Z-58
(2013)

PETITION NO: Z-58

ZONING COMMENTS:

The applicant is requesting a rezoning from R-20 to RA-5 for purpose of residential subdivision. The 1.68 acre site is located on the Northeast intersection of Piedmont Road and Bob Bettis Road, west and south of Fairview Drive.

DRAWING TITLE: ZONING PLAN
DRAWING NUMBER: 01
PLOT DATE: 8/14/2013

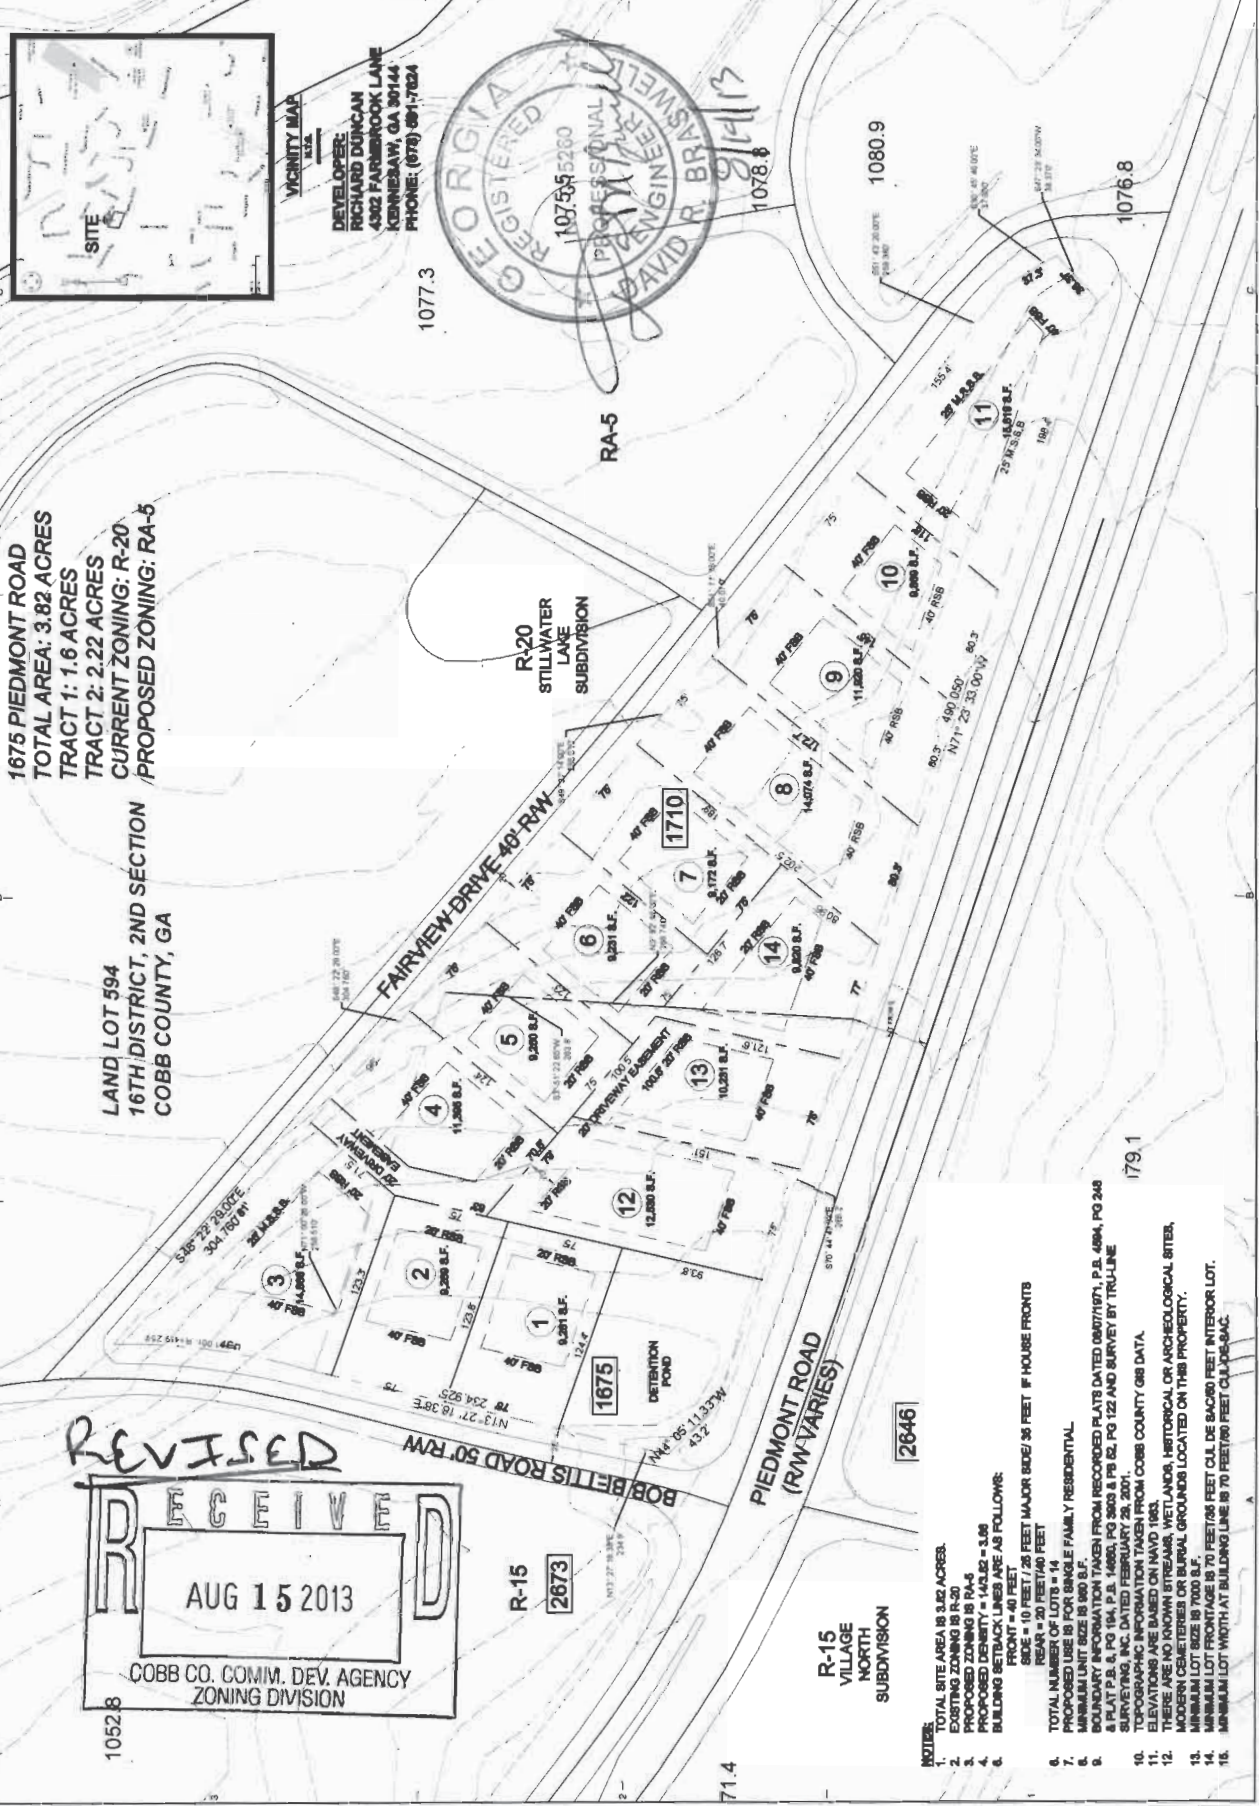
Applicants for Z-56 and Z-58 have submitted a site plan combining the tracts they each had submitted separately. The combined site plan indicates the houses on lots 12 and 13 will be accessed by a 20-foot driveway easement from Fairview Drive. Each lot is over the required 7,000 square-foot minimum lot size for the RA-5 zoning category. Applicants have indicated that the houses will range in price from the \$200,000s to the \$400,000s. Applicant for Z-56 indicated a mixture of siding to include shake, stone and brick. Applicant for Z-58 indicated the houses will be traditional. The site plan originally submitted for Z-56 indicated six lots on an approximate 2.2-acre section of the overall properties, having a density of 2.7 units per acre. The original site plan for Z-58 indicated five lots on a cul-de-sac coming off Bob Bettis Road, being a tract of 1.6 acres having a density of 3.125.

- Provide comprehensive hydrology/stormwater controls to include development of out parcels.
- Submit all proposed site improvements to Plan Review.
- Any **spring activity** uncovered must be addressed by a qualified geotechnical engineer (PE).
- Structural fill _____ must be placed under the direction of a qualified registered Georgia geotechnical engineer (PE).
- Existing facility.
- Project must comply with the Water Quality requirements of the CWA-NPDES-NPS Permit and County Water Quality Ordinance.
- Water Quality/Quantity contributions of the existing lake/pond on site must be continued as baseline conditions into proposed project.
- Calculate and provide % impervious of project site.
- Revisit design; reduce pavement area to reduce runoff and pollution.

- No Stormwater controls shown _____
- Copy of survey is not current – Additional comments may be forthcoming when current site conditions are exposed.
- No site improvements showing on exhibit.

1. This site is located at the northeast intersection of Piedmont Road and Bob Bettis Road. This parcel is contiguous with another zoning case, Z-56. Since these parcels are contiguous and drain to the same discharge point, it is recommended that stormwater management be handled jointly and the developments possibly combined to provide a more efficient layout. The revised plan received 8/15/13 provides for a combined layout. The proposed 20-foot driveway easement will likely need to include a drainage easement as well to provide adequate conveyance of stormwater runoff from lots 4-7 to the proposed detention pond.

Recommend applicant consider entering into a development agreement pursuant of O.C.G.A. 36-71-13 for dedication of the following system improvements to mitigate traffic concerns: a) donation of right-of-way on the south side of Fairview Drive, a minimum of 25' from the roadway centerline.

Recommend curb, gutter, and sidewalk along all road frontages.

Recommend no access easement on Piedmont Road.

- Maximum density of 2.5 units per acre, with the District Commissioner approving the final site plan;
- Fire Department comments and recommendations;
- Water and Sewer comments and recommendations;
- Stormwater Management comments and recommendations;
- DOT comments and recommendations; and
- Owner/developer to enter into a Development Agreement pursuant to O.C.G.A. §36-71-13 for dedication of system improvements to mitigate traffic concerns.
